# VALLEY Talks about Push Chute Extensions

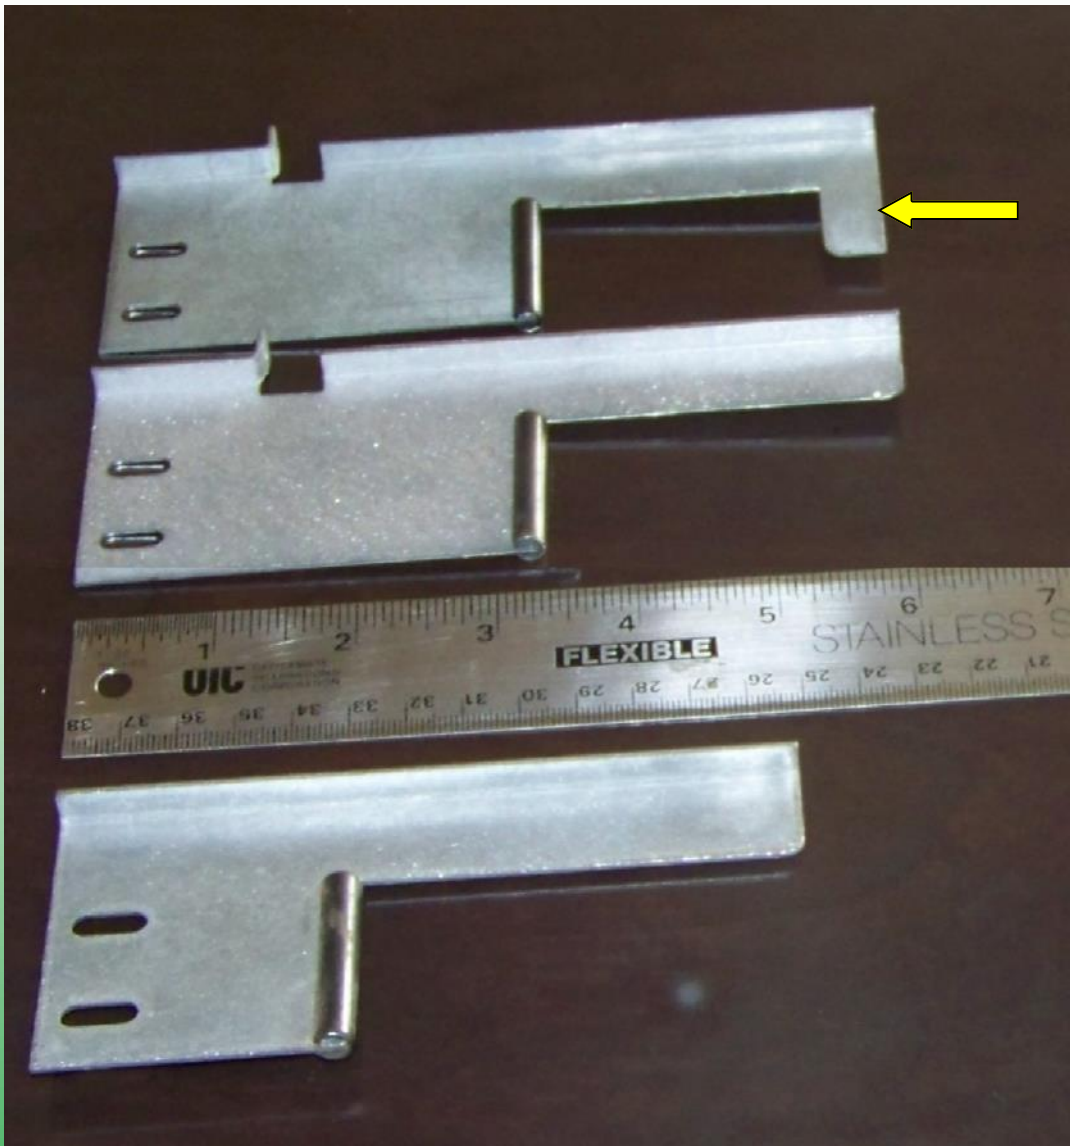
Tables from 1986's model ZD-4 used this extension, but when we introduced the DBA Great 8 we found the little L shape went right where the motor cable wanted to go. All this L does is pull the Ball Trap back down if your \$2 Hinge Bar spring breaks. It was a lot less trouble to stock only one Push Chute end and have operators make sure their spring isn't broken.

All tables since 2002's Valley Great 8 use this extension, even the current Panthers, Top Cats and Dynamo Sedonas on our production line. Note that the hardened piece that contacts the hinge bar is in the exact same place as on the 20600044 extension shown above. Click this box to order it.

Tables prior to 1979's model 39 used this extension—note the shorter distance between the base and the hardened steel roll pin. We still had a few, but sold out in 2012 and no more will be made. Our supplier wanted us to commit to about a 15 year supply for a table that hasn't been produced in nearly 35 years.
